MINUTES

- The Chair then introduced and welcomed representatives from the Maine Department of Transportation (MDOT) and TY Lin, the Department's consulting engineers on the Brunswick-Topsham Bridge project:

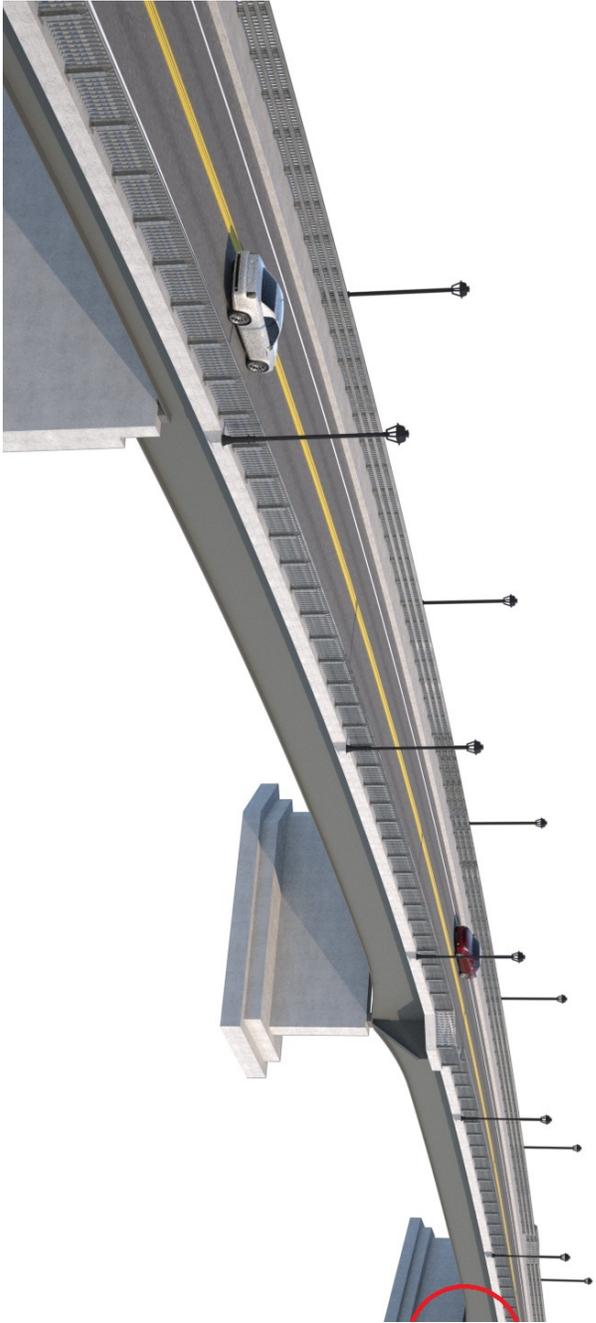
- **Bridge dimensions – below & above deck:**
 - **Measurements:** The measurements below are given as distances or heights below or above the top of the deck, ie: the road surface. These distances are believed to be accurate, based on measurements of the existing bridge and the preliminary plans for the proposed bridge, but are not precise to the inch. The measurements below the deck do not include the piers, and for the proposed new bridge, they do not include the “haunches,” which are flares in the supporting steel beams at the piers. Please see images attached to the end of these minutes.

- **Below deck:** The height of the supporting structure below the road surface of the existing bridge is 6.5 feet, and the height of the supporting steel beams for the proposed bridge would vary from 5 to 9 feet, depending on the span. For the central spans, the height is 8.5 feet. Please see images attached to the end of these minutes.
